Al Christie, 2017 Old Lake City
terrace

Addendum to electric

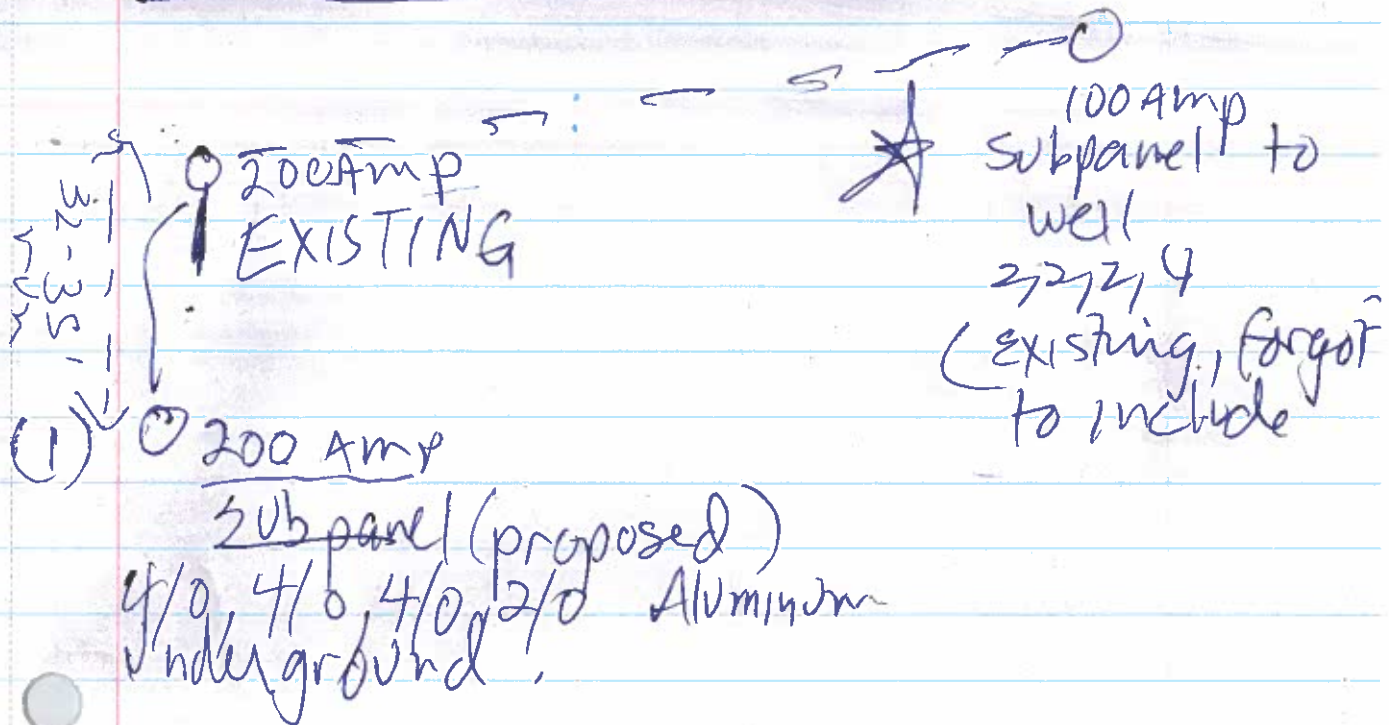
- (2) Run 100 Amp to trailer
existing 100 breaker
2/0, 2/0, 1/0, 1 or 2224
Aluminum. This will
eliminate the need to go
under trailer and existing
200 power pole has only
8 spaces
